UNITED STATES PATENT AND TRADEMARK OFFICE

10/655,854

Office Action Summary

DETAILED ACTION

FIG. 3

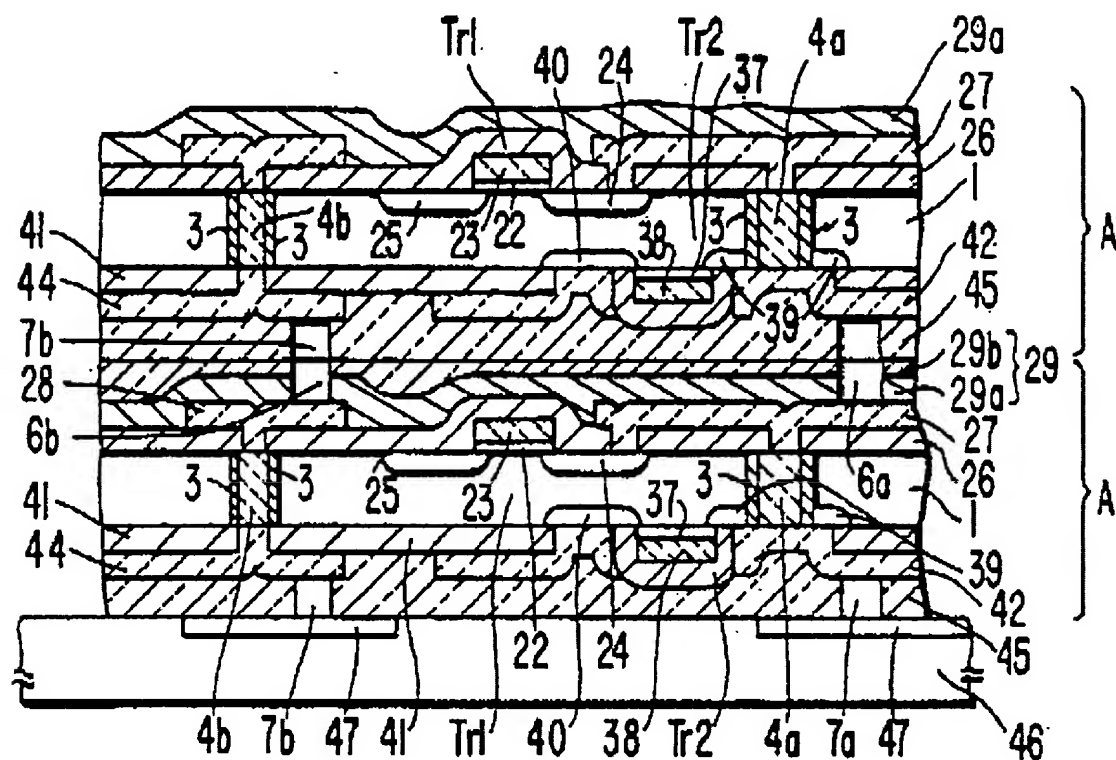
7. Regarding claim 17, Kato (e.g. fig. 3) show a multi layer integrated semiconductor structure, comprising:

A first device layer 1 including:

- First and second opposing surface
- A first semiconductor region (24, 25);
- A first dielectric material 29 disposed about the first doped semiconductor region, the dielectric material having at least a first via hole 6a;

A first conductive material 6a disposed in the via hole to provide a first conductive via having first and second opposing ends;

A second device layer 1 having first and second opposing surfaces including:

- At least a second doped semiconductor region (24, 25) and including a second via hole 4a; a second conductive material 4a disposed therein to provide a second conductive via having first and second ends;

A first interface "7a" (not labeled in the in figure 3 but located between 6a and 45) disposed between a first one of the first and second opposing surfaces of the first device layer and a first one of the first and second opposing surfaces of the second device layer such that the first interface secures together the first and second device layers and also electrically couples the first device layer to the second device layer wherein the conductive interface and the first and second conductive vias forms at least

a portion of an electrical communication path between the first device layer and the second device layer.

8. Regarding claim 18, Kato shows a first conductive interconnect element 27 disposed in the first layer with a first portion of the first conductive via electrically coupled to at least a portion of the first conductive interconnect element and a second portion of the first conductive interconnect element coupled to the first doped semiconductor region.
9. Regarding claim 19, Kato shows that the first conductive via couples the first conductive interconnect element to the first conductive interface.

10. Regarding claim 20, Kato shows that the second conductive via is formed on the first one of the first and second opposing surfaces of the second device layer and is coupled to the second doped semiconductor region.

11. Regarding claim 21, Kato shows a third conductive via 4a coupled to the second doped semiconductor region.

12. Regarding claim 22, Kato shows a second conductive interface 7a disposed on the second one of the first and second opposing surfaces of the second device layer and wherein the third conductive via is provided having a first end coupled to the second doped semiconductor region and a second end coupled to the second conductive interface.

13. Regarding claim 23, Kato shows that the second conductive via is formed on the first one of the first and second opposing surface of the second device layer and wherein the second device layer comprises a first conductive interconnect 27.

14. Regarding claim 24, Kato shows that the second conductive via is provided having a first end coupled to the conductive interconnect 27 and a second end coupled to the first conductive interface.

15. Regarding claim 25, Kato shows that the first conductive via is coupled to at least the first doped semiconductor region.

16. Regarding claim 26, Kato shows that the first conductive via is provided having a first end coupled to at least the first doped semiconductor region and a second end coupled to the first conductive interface.

17. Regarding claim 27, Kato shows that the first interface corresponds to a first conductor interface region (right side). Also, a second interface region (left side) is disposed between the first one of the first and second device layers with the second interface region provided from a non-conductive material 29b.

27. Regarding claim 38, Kato shows a first conductive interconnect element 27 having a first portion coupled to the first doped semiconductor region, and a second portion coupled to a first end of the first conductive via.

28. Regarding claim 39, Kato shows a second conductive interconnect element 27 having a first portion coupled to the second doped semiconductor region and a second portion coupled to a first end of the second conductive via with the second end of the first conductive via and the second end of the second conductive via each coupled to the first interface.

29. Regarding claim 40, Kato (e.g. fig. 3) shows a multi layer integrated semiconductor structure, comprising: a first semiconductor wafer 1 including a plurality of semiconductor structures (transistors) each of which includes a first plurality of semiconductor elements (24, 25, 27); a second semiconductor wafer 1 including a second plurality of semiconductor structures (transistors) each of which includes a second plurality of semiconductor elements (24, 25, 27); and at least a first conductive

bonding interface segment 7b disposed between the first and second semiconductor wafers; the first conductive bonding interface segment disposed over at least a first one of the plurality of semiconductor structures of the first semiconductor wafer and being in an electrical communication relationship with at least a first one of the first plurality of the semiconductor elements of the first semiconductor structure and; first one of the plurality of semiconductor elements of the second semiconductor structure of the second semiconductor wafer where the first conductive bonding interface segment permits at least the first semiconductor element of the first semiconductor structure to communicate with at least the second semiconductor element of the second semiconductor structure.

FIG. 2(a)

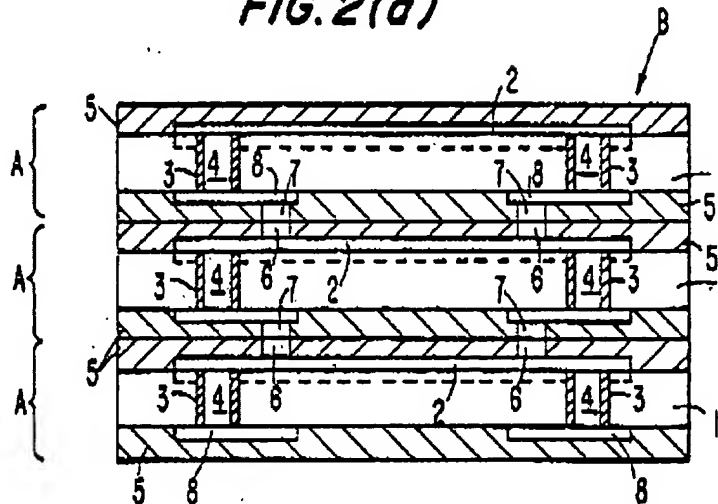
30. Regarding claim 41, Kato shows (e.g. figs. 2a and 3) shows a multi layer semiconductor structure, comprising: at least a first semiconductor structure 1 including a first plurality of conductive elements 4; at least a second semiconductor structure 1 including a second plurality of conductive elements 4; a first plurality of conductive bonding interface segments 7 disposed between the first and second semiconductor structures with each of the plurality of conductive bonding interface segments being in an electrical communication relationship with one or more of the conductive elements of the first semiconductor structure and one or more of the conductive elements of the second semiconductor structure; at least a third semiconductor structure 1 including a third plurality of conductive elements 4 and a second plurality of conductive bonding interface 7 disposed between the second and third semiconductor structures with each of the second plurality of conductive bonding interface segments being in electrical

communication relationship with one or more of the conductive elements of the second semiconductor structure and one or more of the conductive elements of the third semiconductor structure.
